Our Ref: 12444-2 Devizes Castle Moat Bridge

Devizes Castle Moat Bridge

Comment in reply to Historic England – Ancient Monuments Comment No. WC-26-02-363280 by Joanne Fisher dated 13/02/2026

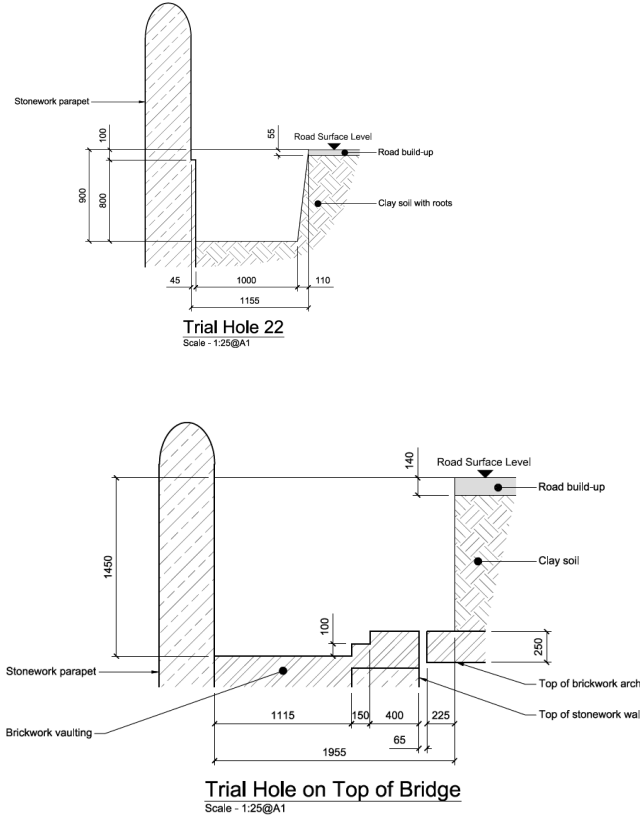
Ref	Historic England Comment	Clive Haywood Response	Comment
1	The structural repairs are shown on the Scott & Twine drawings which refer to a 'structural specification' in several places. A structural specification has not been included in the information submitted for the listed building consent.	Specification now attached	
2	The drawings do not pick up all of the structural work recommended to the main structure of the bridge in the structural report. • Cintec anchors are only shown on the west side of the bridge • No grouting is recommended	Correct, on review, when the drawings were produced it was considered that the eastern elevation did not require tying and the main intervention was the western elevation where there is a clear separation between the various phases of building. Now included in the specification and the gap of concern is to the western arches as shown on photographs No.48 to No.50 in the report.
